CITY OF ST. AUGUSTINE CORRIDOR REVIEW COMMITTEE

A G E N D A

5. (a) HP2023-0022 – Grace Construction Consultants, LLC - Applicant Sebastian Marina, LLLP - Owner– 169 King Street

For design review of a new restaurant development along the King Street Entry Corridor.

ELEVATION (FRONT)

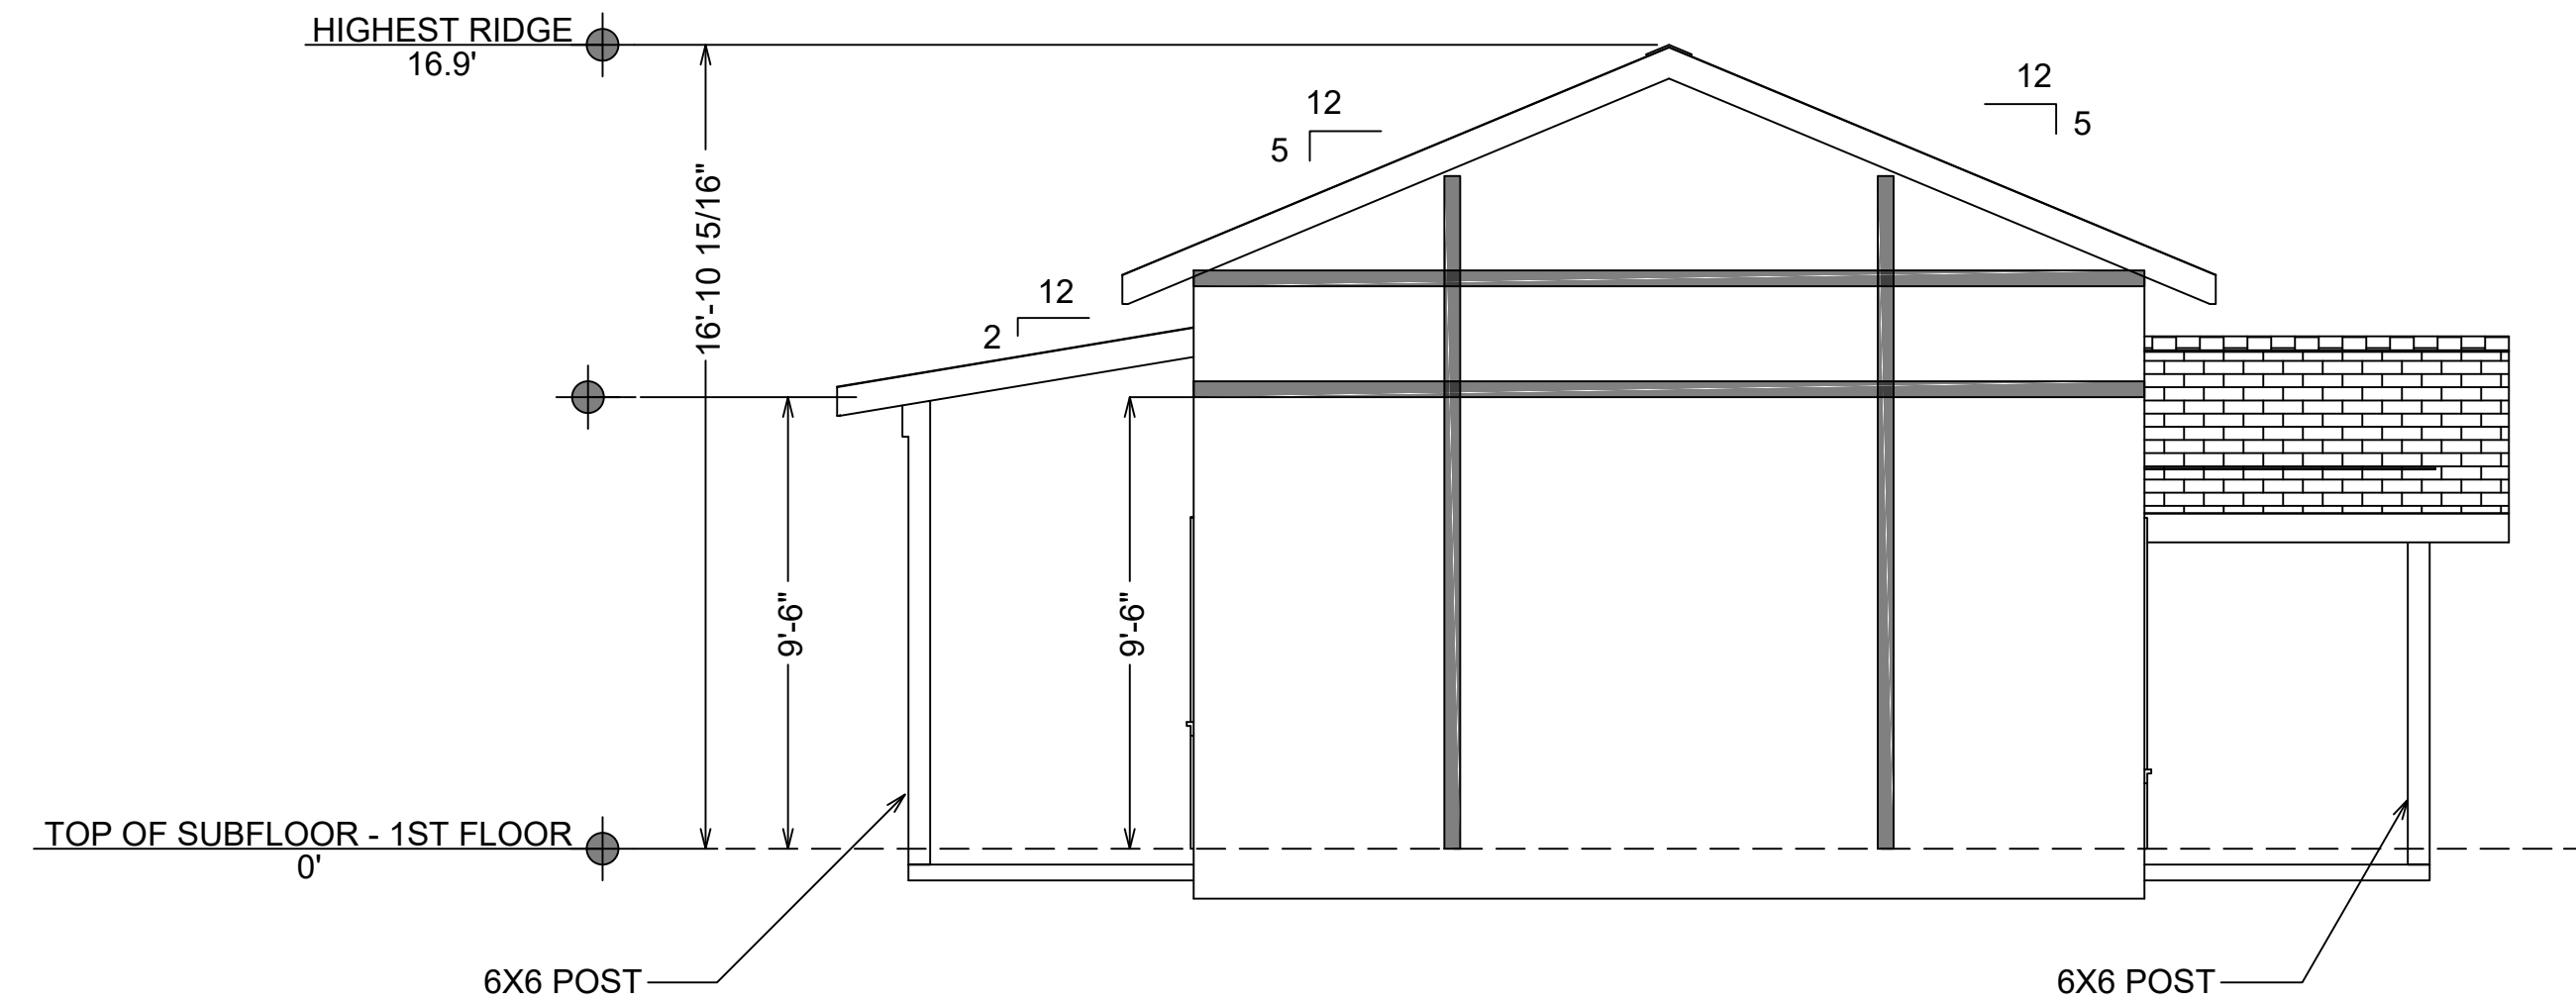
2. Currently proposed glazing on the front elevation appears to be insufficient to meet the 30% minimum requirement which is 96 sf for a building this size. The minimum glazing approvable by the CRC is 85.44 sf. While the window sizes on the front elevation are not clearly labeled, the windows as-shown are not likely to meet this measurement. The applicant has stated they are updating the front elevation to meet this, but no update has been received as of the drafting of this report. Unless otherwise proven or modified by the applicant, the glazing as proposed would require a variance from the Planning and Zoning Board.
